The 55 details drawn differently in CAD and Revit

Checked against the new drafters' file, 26 October.

55 of the 190 CAD typical details have a Revit version in your templates that is drawn differently. Each page: your CAD detail on the left, the Revit version on the right, what differs, and one answer: CAD is right, Revit is newer (we update CAD from it), or both wrong.

CAD: KOR-D301-DET 04 - BASEMENT WALL SECTION

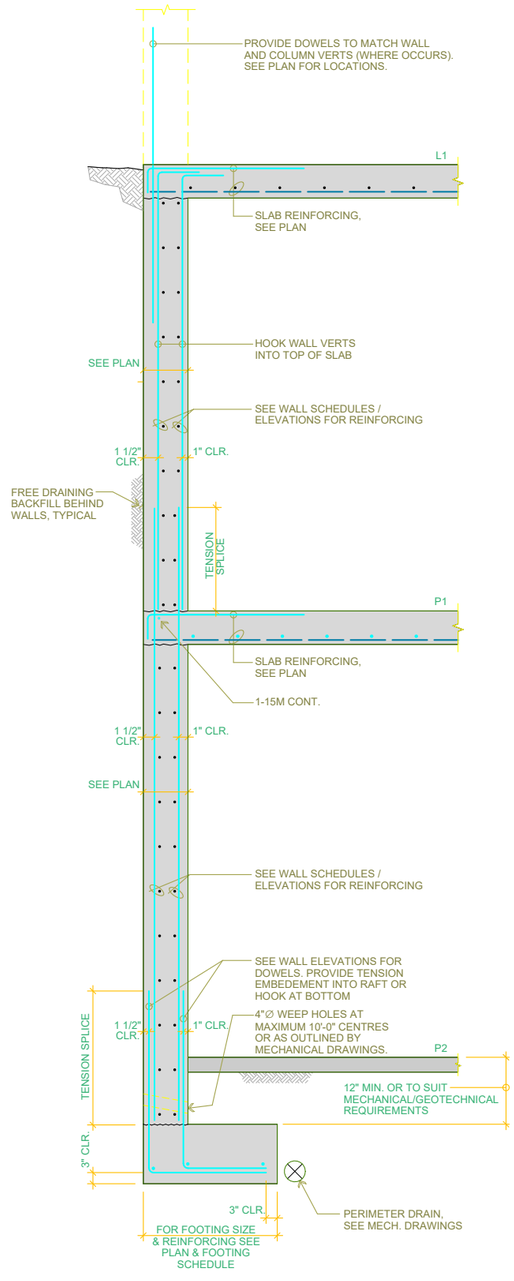
What differs: Single-storey basement wall with slab dowels and footing; 'D3.01_1_BASEMENT WALL SECTION' shows three levels.

Revit: D3.01_1_BASEMENT WALL SECTION (Typical Details - Container_R23 (Need_MET & IMP).rvt; on D3.01 Series 3 Basement)

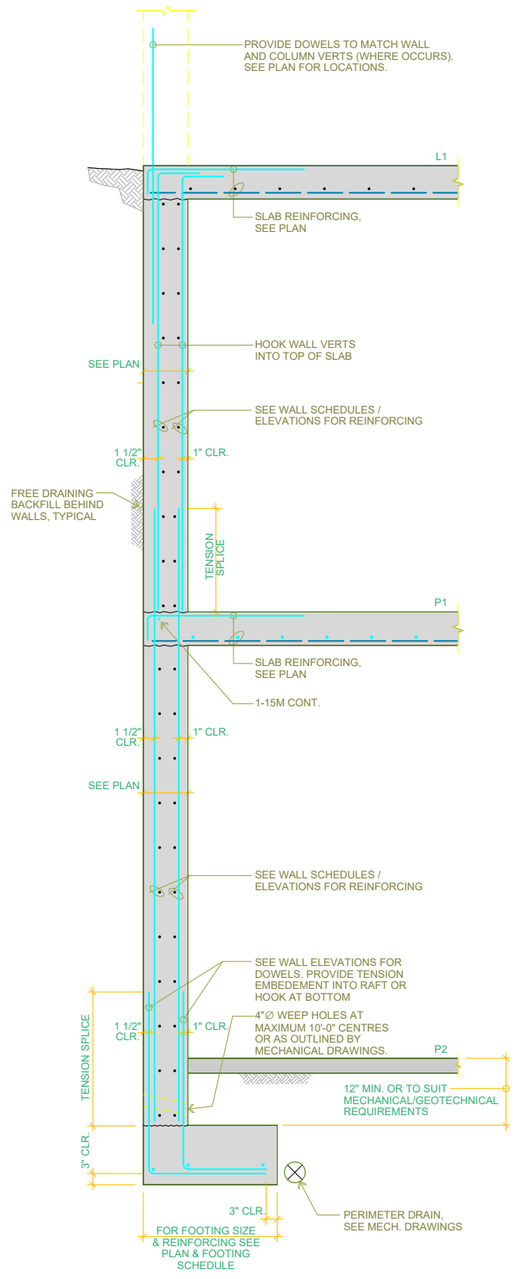
What differs: Tall multi-storey wall with five slabs; 'D3.01_1_BASEMENT WALL SECTION' shows three levels and different callouts.

Revit: D3.01_1_BASEMENT WALL SECTION (Typical Details - Container_R23 (Need_MET & IMP).rvt; on D3.01 Series 3 Basement)

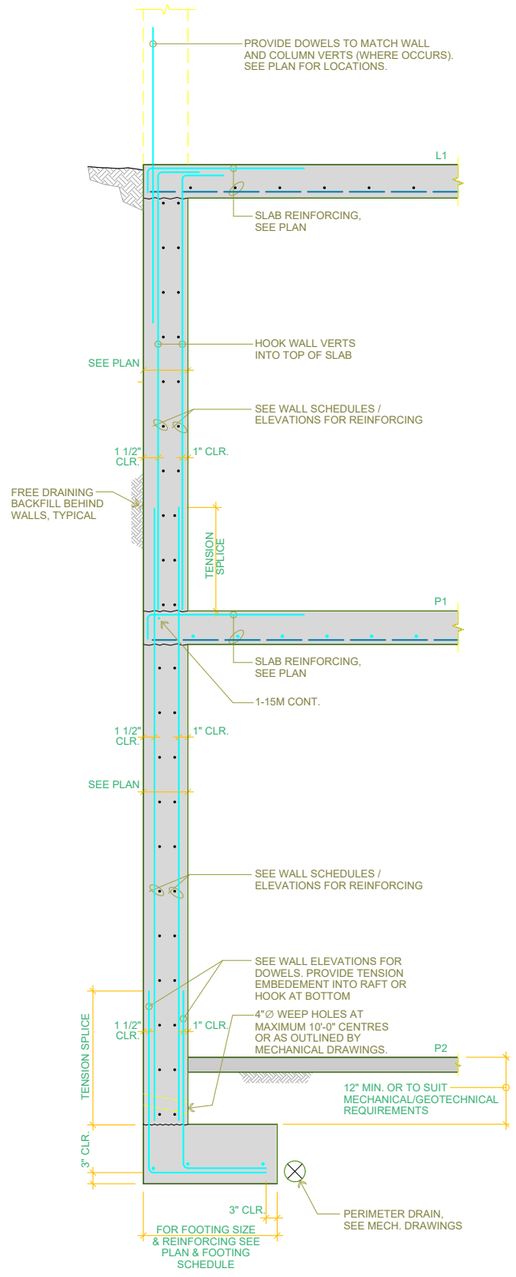
What differs: Tall multi-storey wall with five slabs; 'D3.01_1_BASEMENT WALL SECTION' shows three levels and different callouts.

CAD: KOR-D302-DET 01 - BASEMENT WALL SECTION

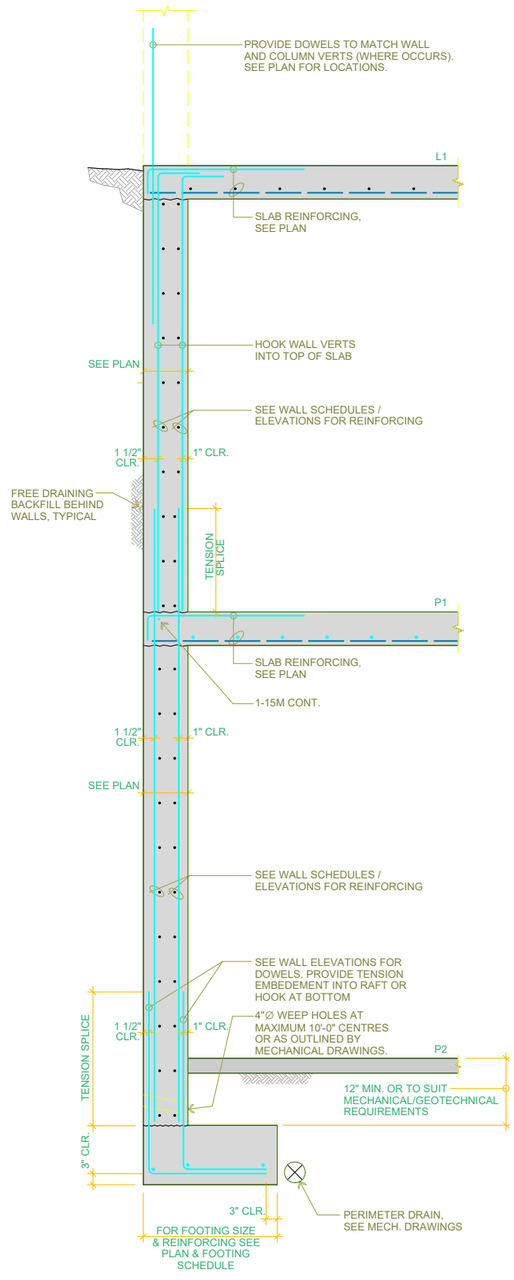
What differs: Basement wall section bearing on a raft instead of a strip footing; otherwise like 'D3.01_1_BASEMENT WALL SECTION'.

CAD: KOR-D302-DET 02 - BASEMENT WALL SECTION

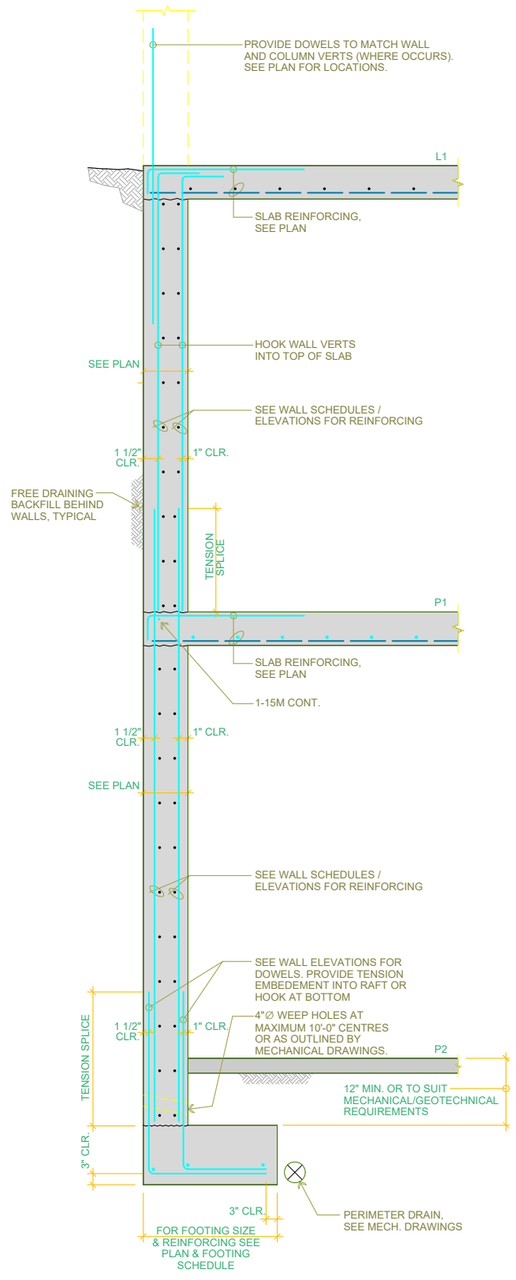
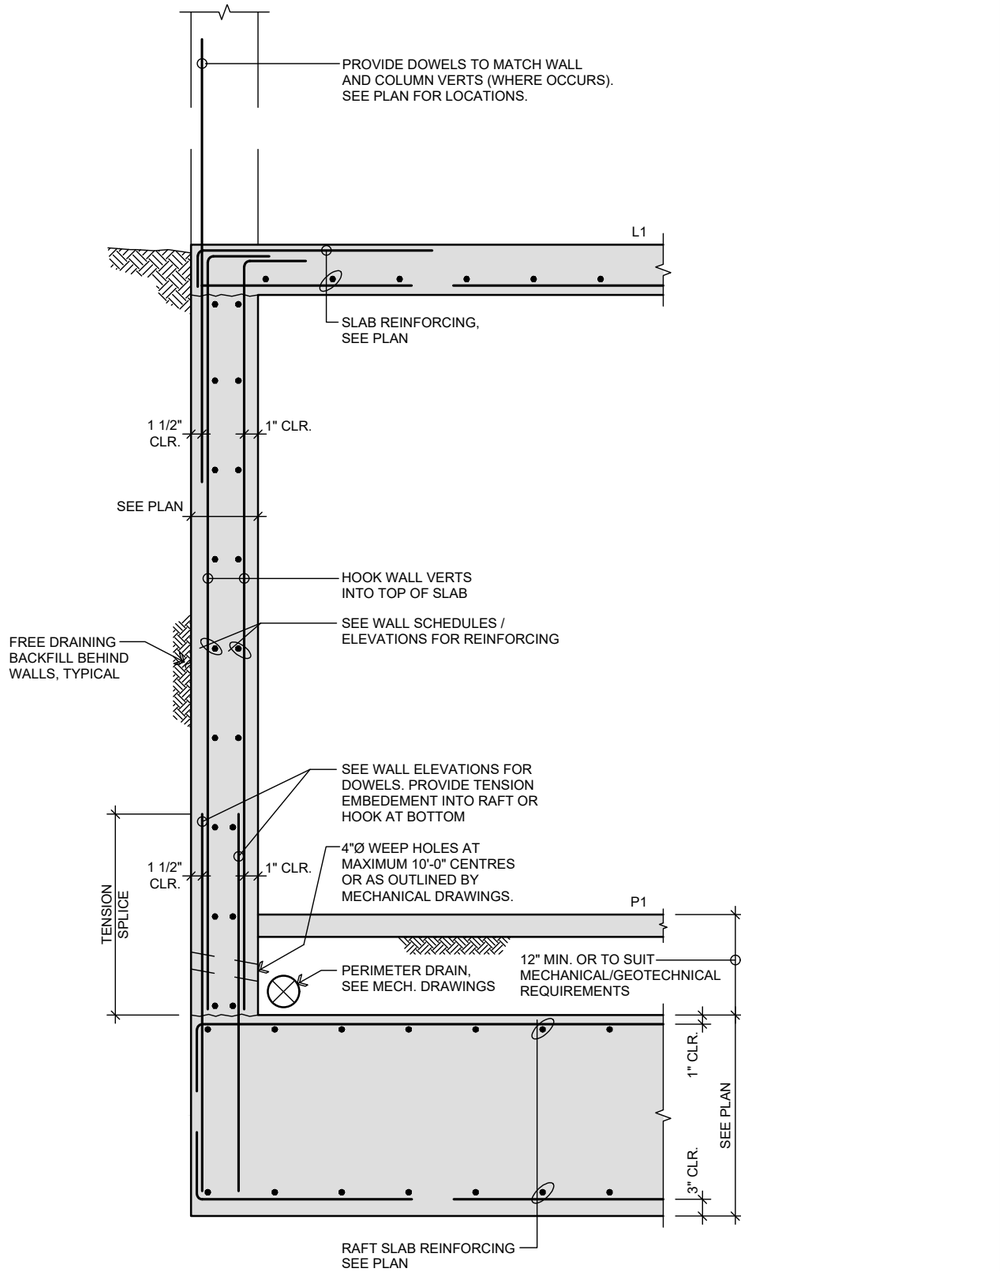
What differs: Basement wall on a raft with extra callouts vs 'D3.01_1_BASEMENT WALL SECTION''s strip footing.

CAD: KOR-D302-DET 03 - BASEMENT WALL SECTION

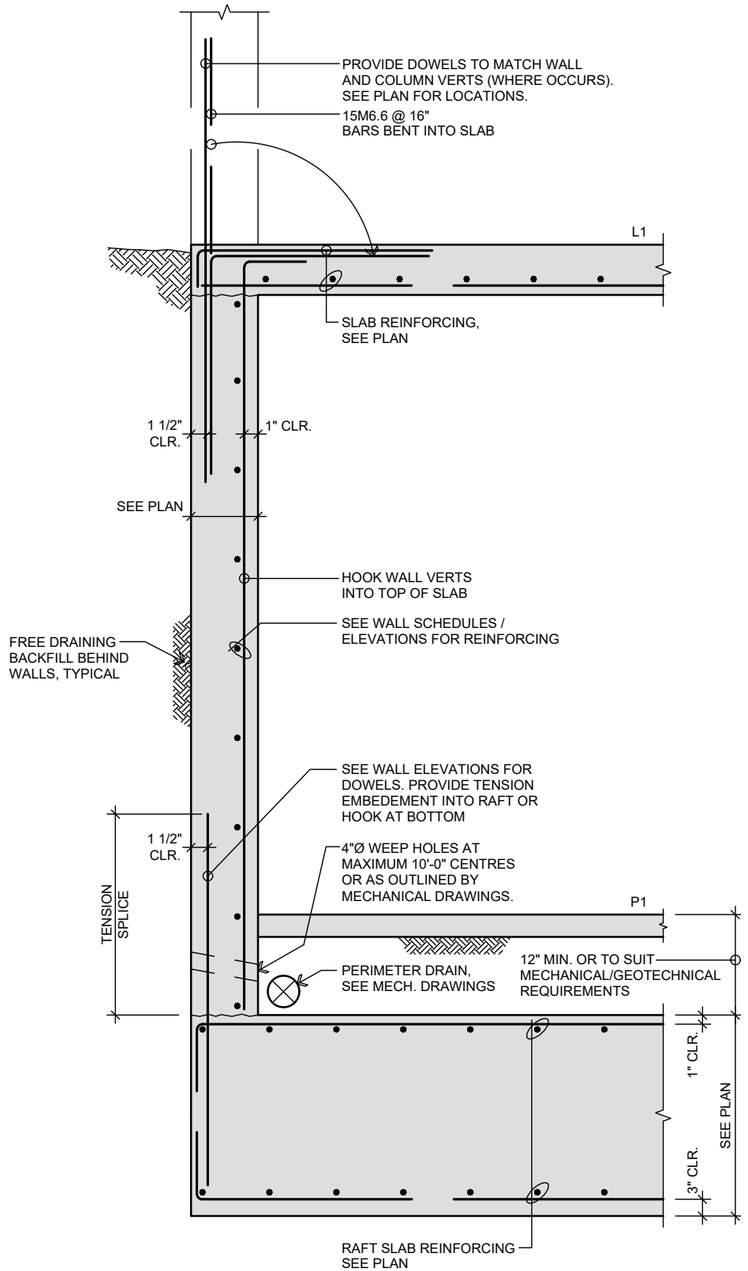
What differs: Single-storey basement wall on raft; 'D3.01_1_BASEMENT WALL SECTION' is three levels on strip footing.

CAD: KOR-D302-DET 05 - BASEMENT WALL SECTION

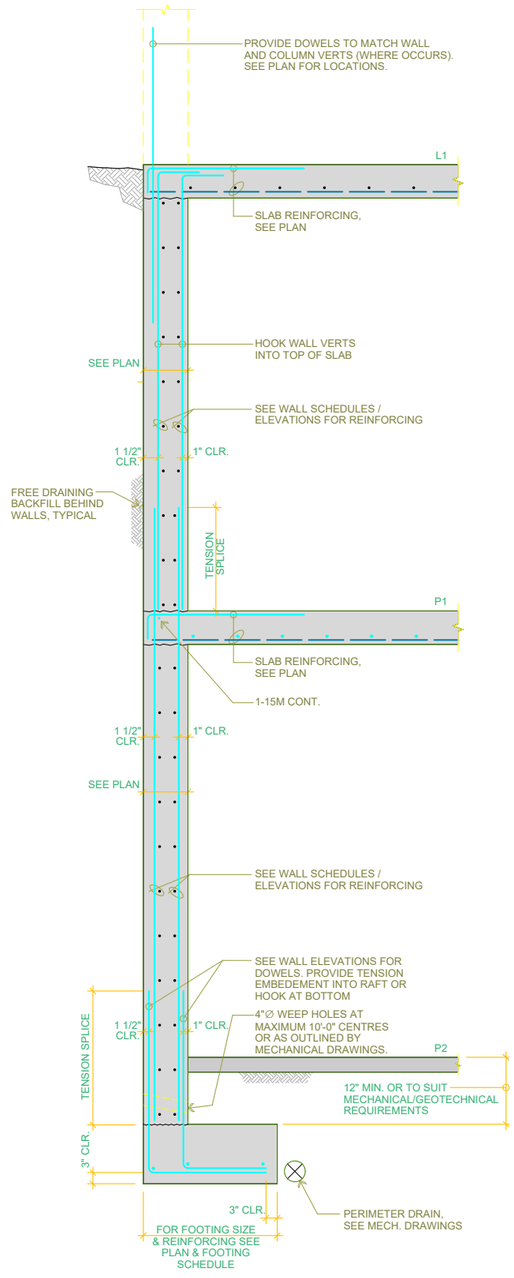
What differs: Tall multi-storey wall on raft; 'D3.01_1_BASEMENT WALL SECTION' is three levels on strip footing.

CAD: KOR-D302-DET 06 - BASEMENT WALL SECTION

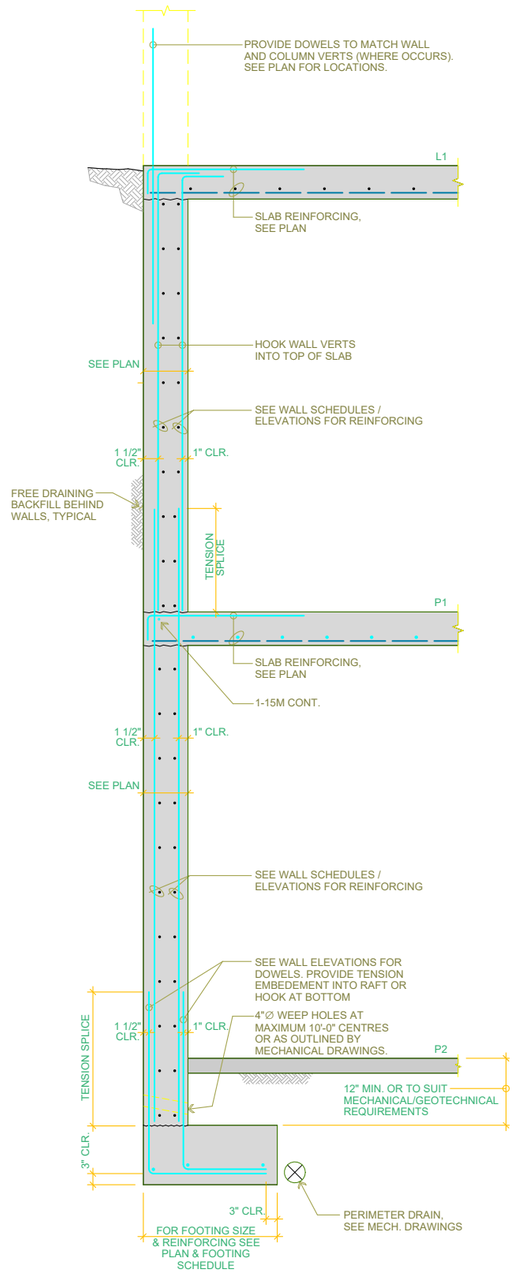
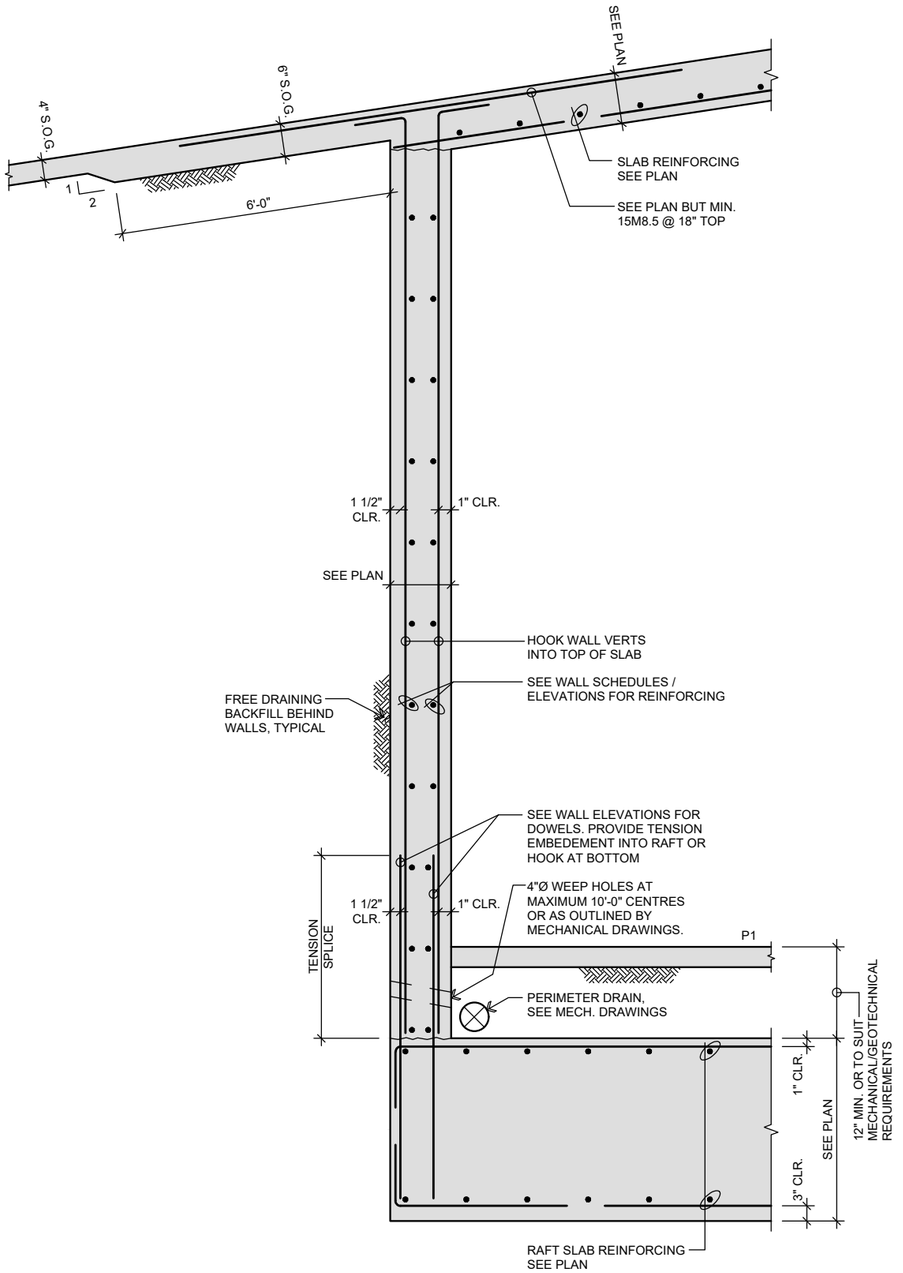
What differs: Tall multi-storey wall on raft; 'D3.01_1_BASEMENT WALL SECTION' is three levels on strip footing.

CAD: KOR-D302-DET 07 - BASEMENT WALL SECTION

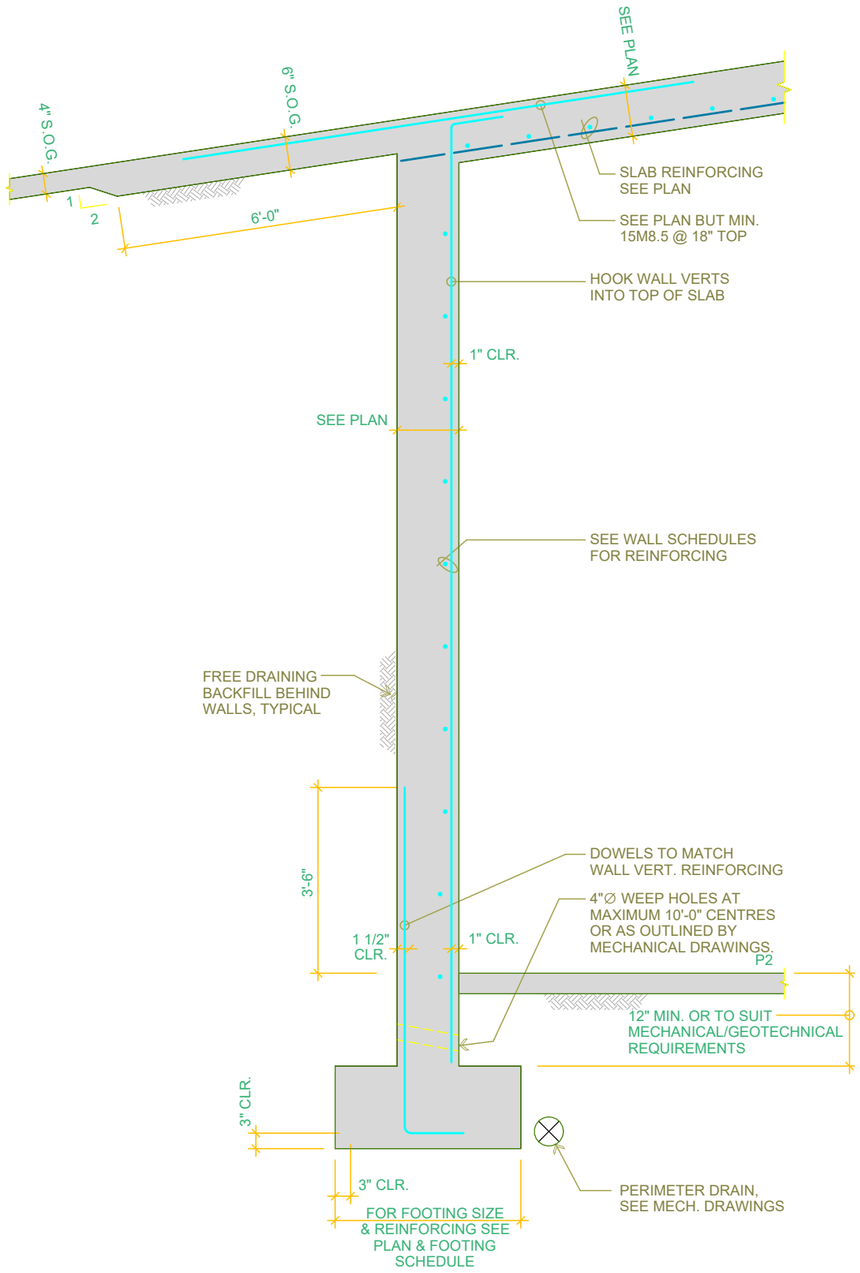
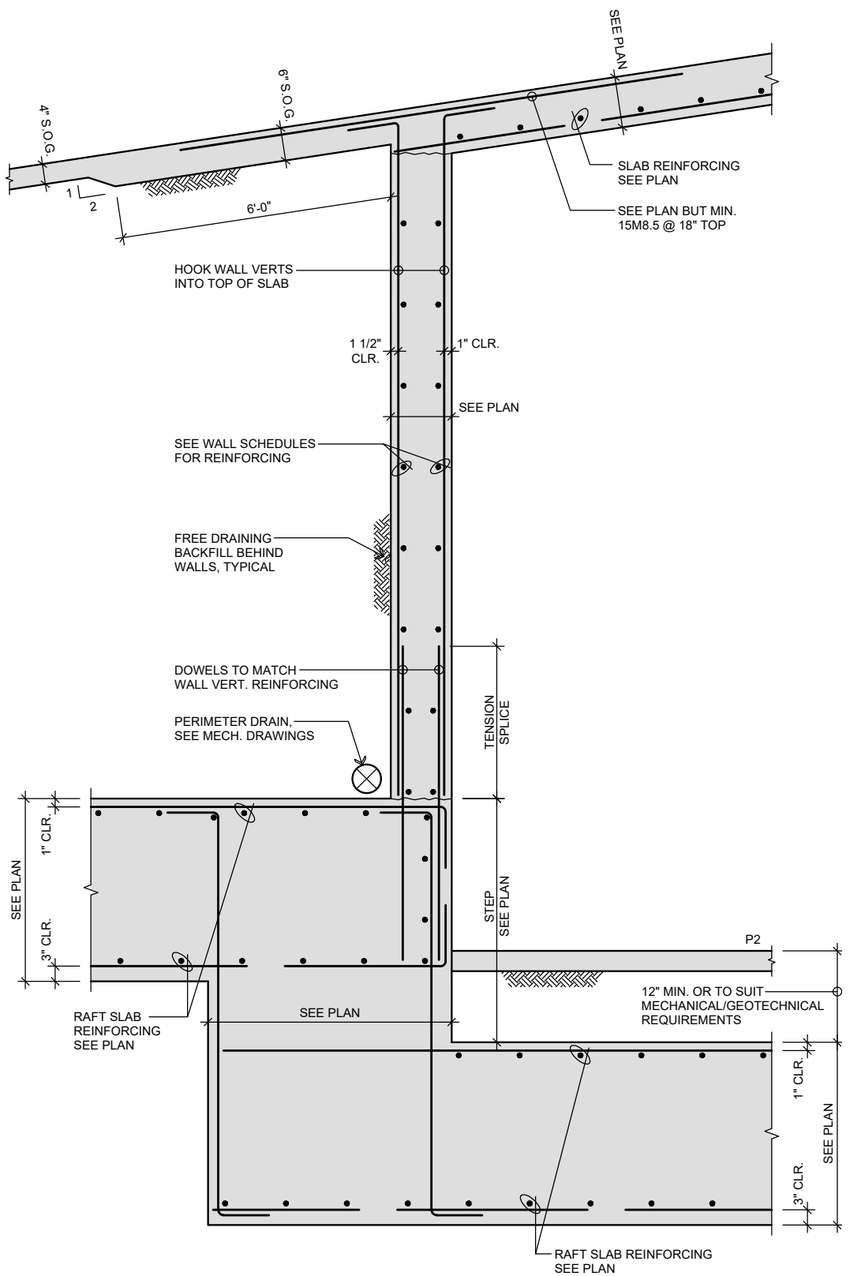
What differs: Wall with sloped slab over as 'S5.05_1_BASEMENT WALL DETAIL' but bearing on a raft rather than a strip footing.
